## Planning Commission Vote Report

**Petition:** **PZ 12-2020 The Residences at Hog Hollow (14001 Olive Blvd):** A request for a change in zoning from R-3 Residence District to PUD Planned Unit Development for a maximum of 100 residential units (16R340151).

Re: P.Z. 12-2020 The Residences at Hog Hollow, 14001 Olive Blvd., City of Chesterfield, MO -  
Response Letter to Comments Dated 12/16/2020 (Stock Project No. 219-6568)

**Two(2) Photos of Existing Chain Link Fence Along  
West Property Line of Chesterfield Management  
Associates, LP & East Property Line of Keymer  
Realty & Investments LLC**

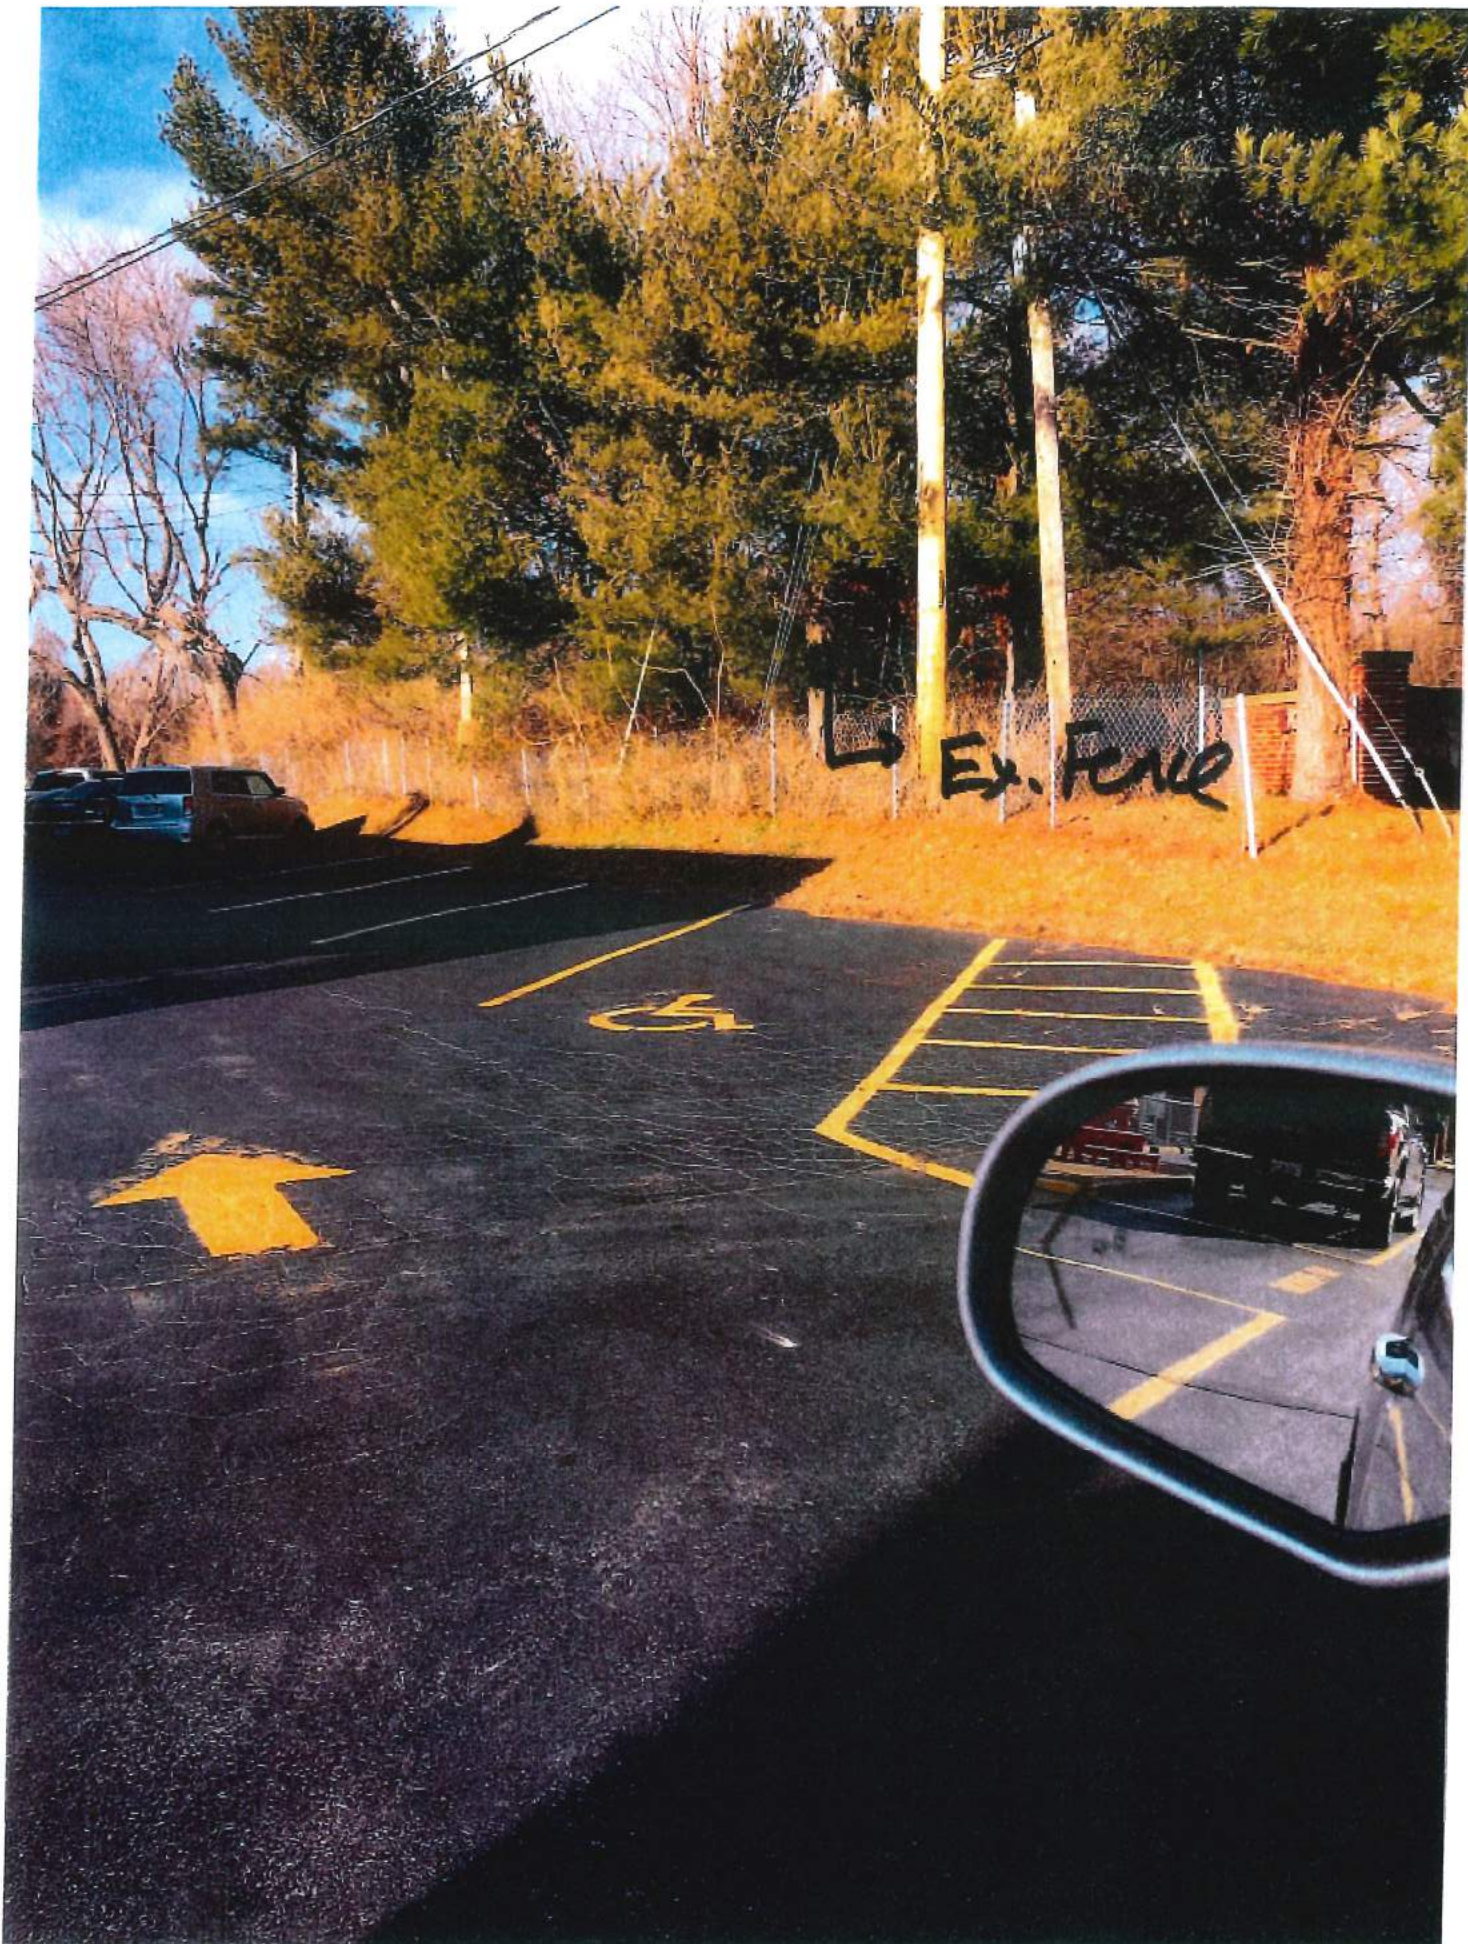
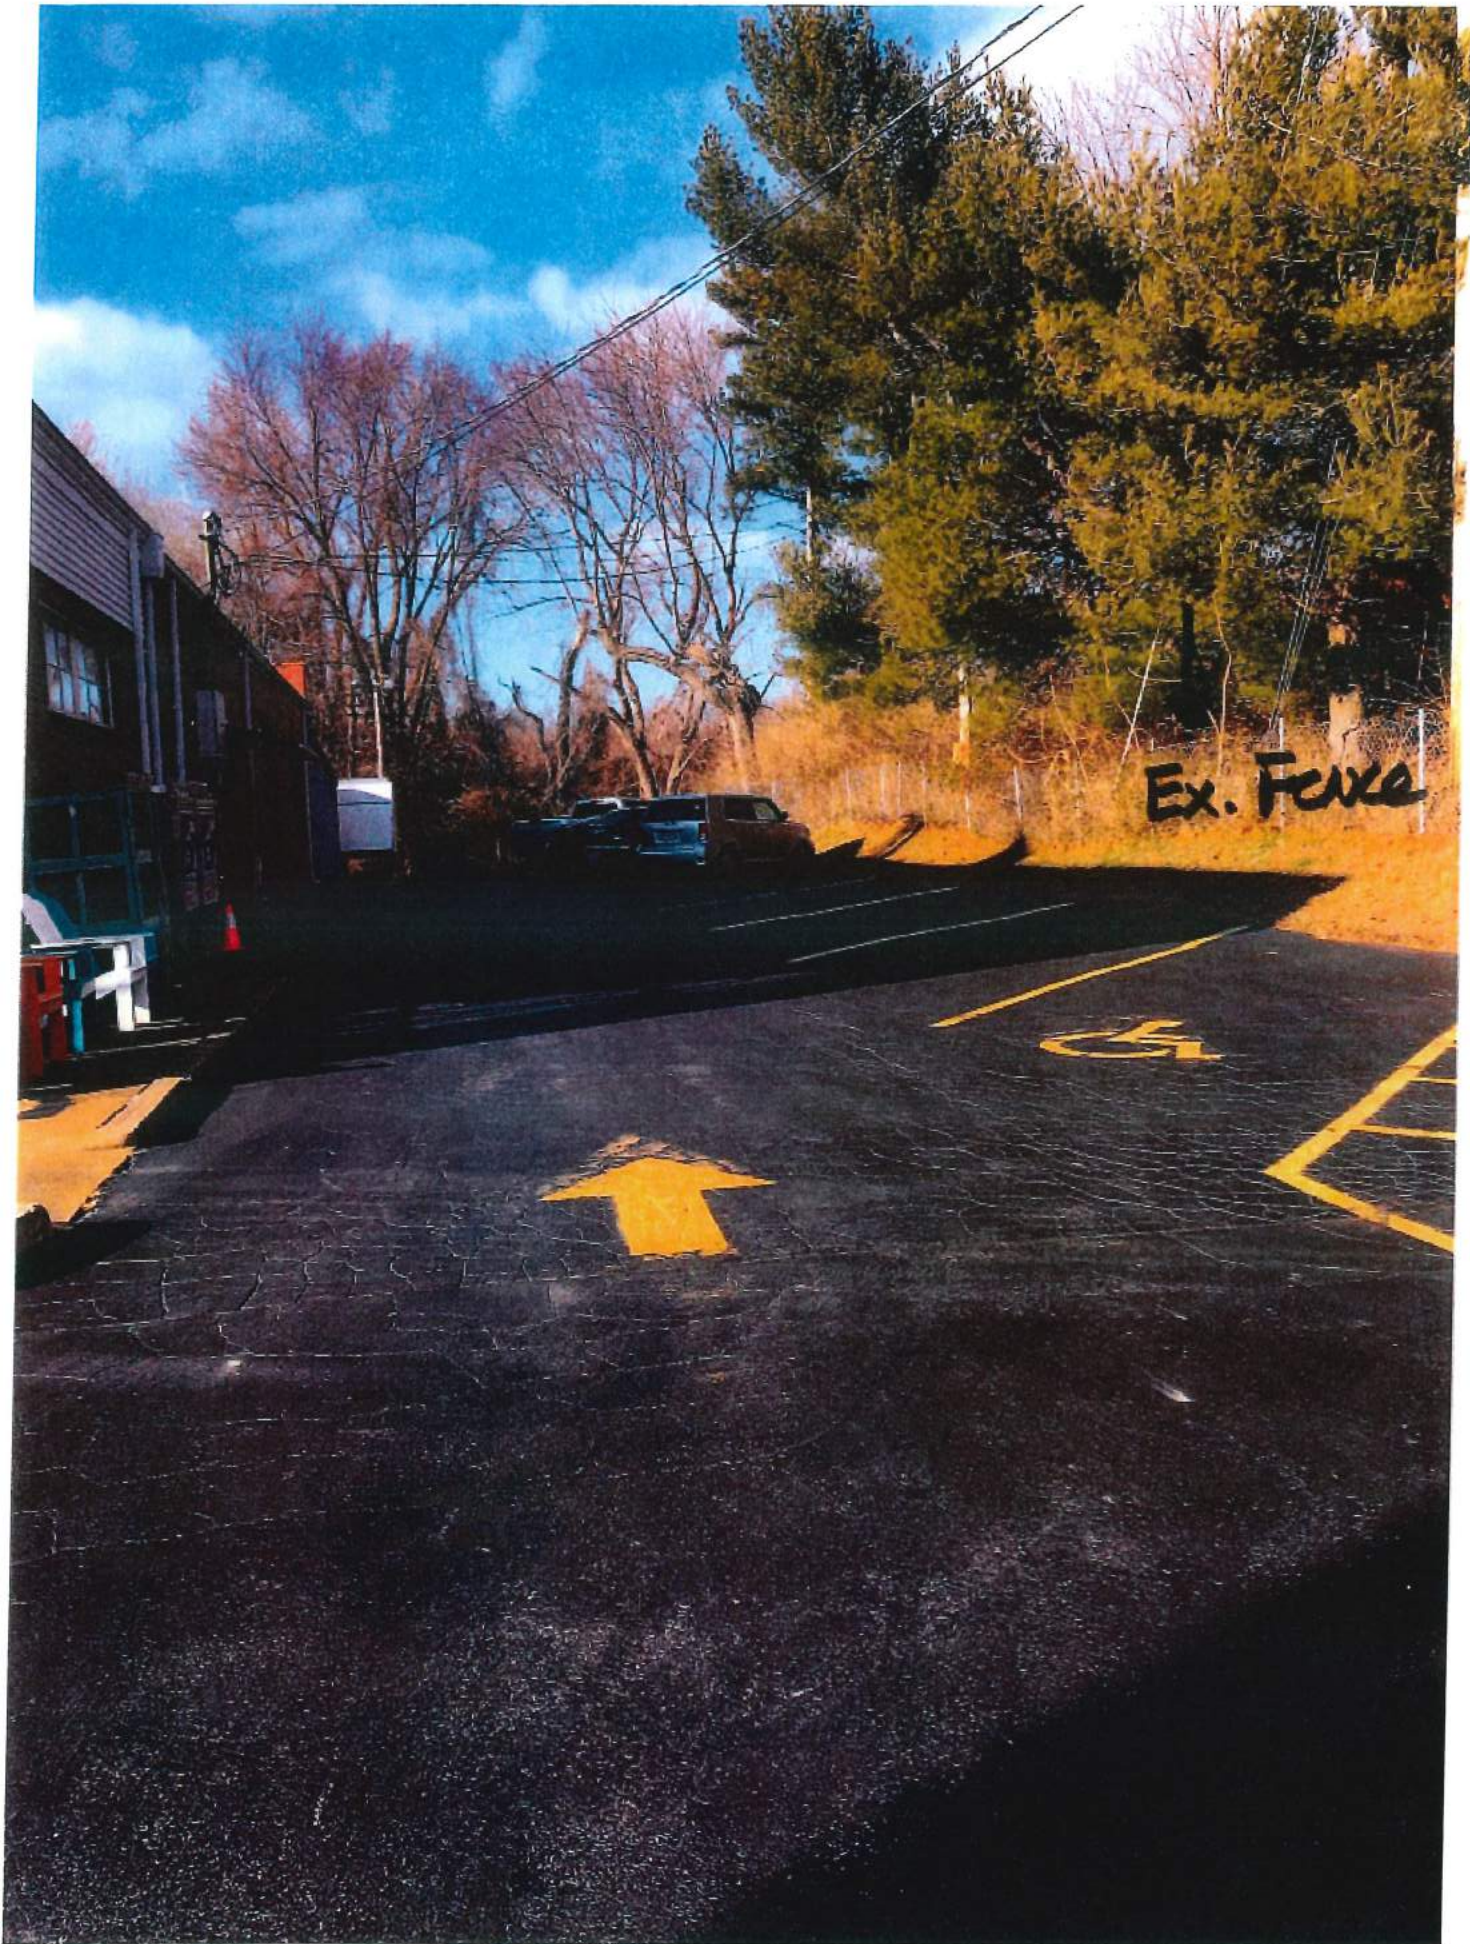
3. 14015 Olive Boulevard: There were several items discussed relating to 14015 Olive Boulevard:
  - a. Fencing: The property owner of 14015 Olive Boulevard requested a fence in order to screen his property from residents of the proposed development. In ensuing discussion, it was noted that there may be difficulties with sight distance should the fence be installed on the eastern boundary of 14015 Olive Boulevard, along the proposed entry road to the development. Provide information on the fence and depict on the Preliminary Plan.

**Response: A sight proof fence is not a requirement of the 30-foot Landscape Buffer. The Landscape Buffer will be planted and maintained by the Home Owners Association in Accordance with City Code and an approved Site Development Plan. The Owner/Developer of the Residences at Hog Hollow is "Not Opposed" to the adjoining property owner (Keymer Reality & Investments, LLC) installing and maintaining a sight proof fence on their property, today a chain link fence exists between the two (2) properties (photos attached).**

**One (1) Photo of Existing “LPG” Tank & 2005 Survey  
Showing Location on the 14015 Olive Blvd. Property**

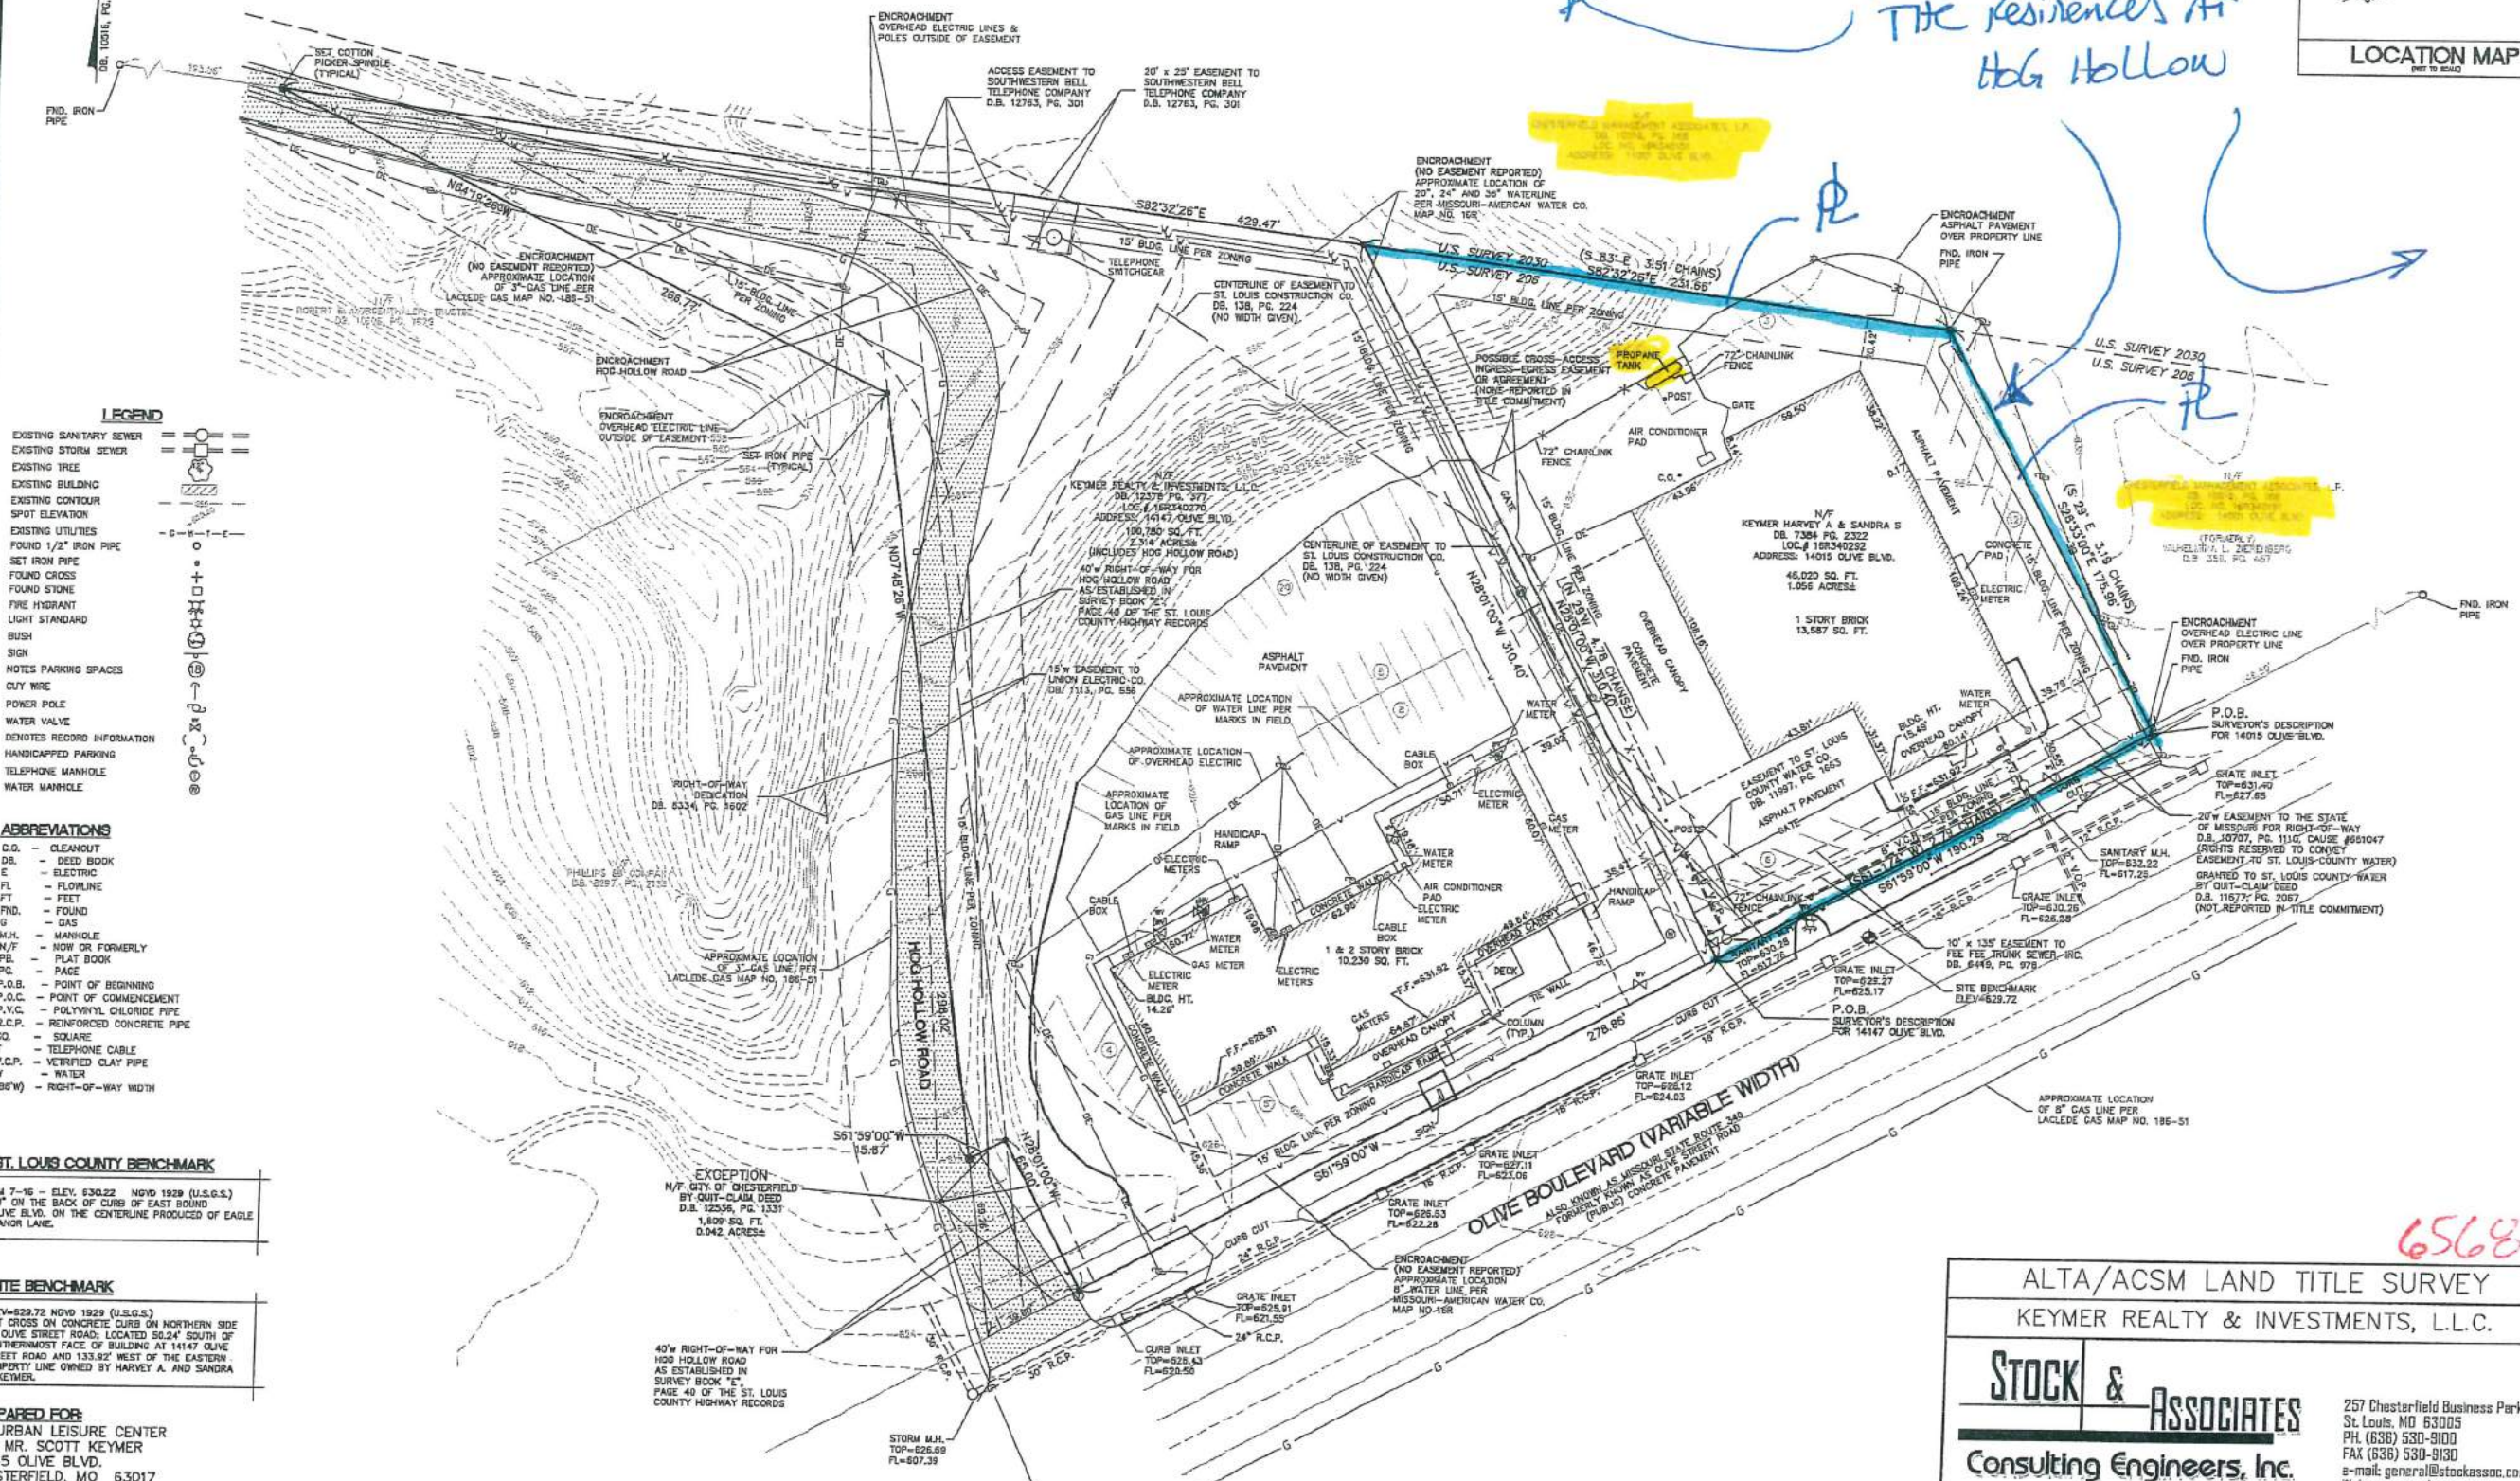
- b. Propane tanks: It was noted that there may be safety issues with the propane filling that occurs at 14015 Olive Boulevard and maintaining adequate distance between the propane tanks and any structures proposed in this development. Provide information on the required safety distance between propane tanks and structures.

**Response: The Owner/Developer of the Residences at Hog Hollow believe that it is the responsibility of the property owner & operator of the existing Liquefied Petroleum Tank to operate in accordance with all City, County, State, Federal, & OSHAA Guidelines. Attached is information from St. Louis County Department of Public Works & The Monarch Fire District regarding the LPG Tank. Attached is a 2005 Survey & Current photo of the tank's location on the 14015 Olive Blvd. Property.**

SHEET NO.:  
**C1.0**

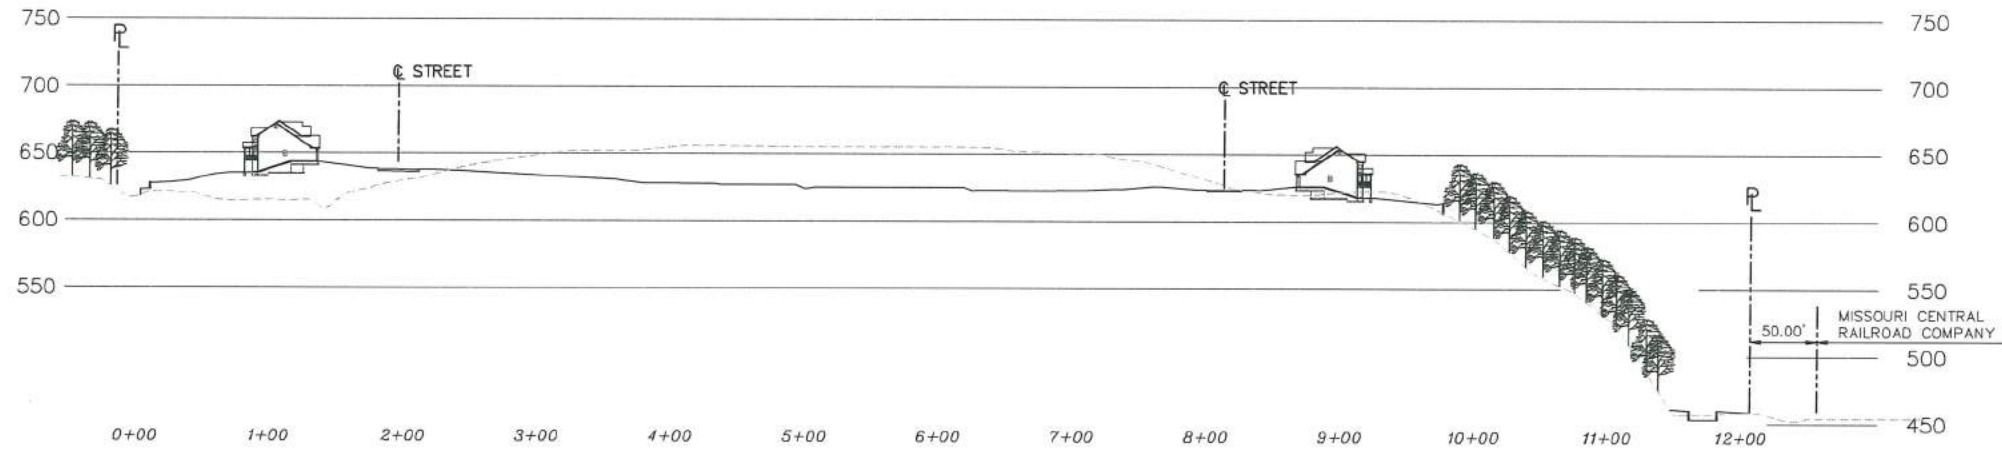
2. **Amenities:** There was discussion regarding the amenities displayed on the Preliminary Plan. While the Planning Commission appreciated the amenities shown on the Preliminary Plan, there was a question as to whether it would be possible to incorporate additional amenities throughout the site, rather than having the amenities concentrated at two ends of the site in the proposed pocket parks. Provide information pertaining to the potential for additional amenities.

*The applicant has provided updated trip generation figures. Per CBB, the peak number of “AM” trips is 15 vehicles in and 49 vehicles out. The peak number of “PM” trips is 53 vehicles in and 31 vehicles out. Additionally, the applicant reached out to the Missouri Department of Transportation (MoDOT) regarding the possibility of a three lane road leading into the development, to which MoDOT has no objection. The applicant has depicted a three lane road on the revised Preliminary Plan.*

REVISIONS:  
 1. 11-25-2020 REV PER CITY COMMENTS 11-17-2020  
 2. 01-12-2021 REV PER CITY ADDED THREE LANE ENT. REVISED SETBACKS
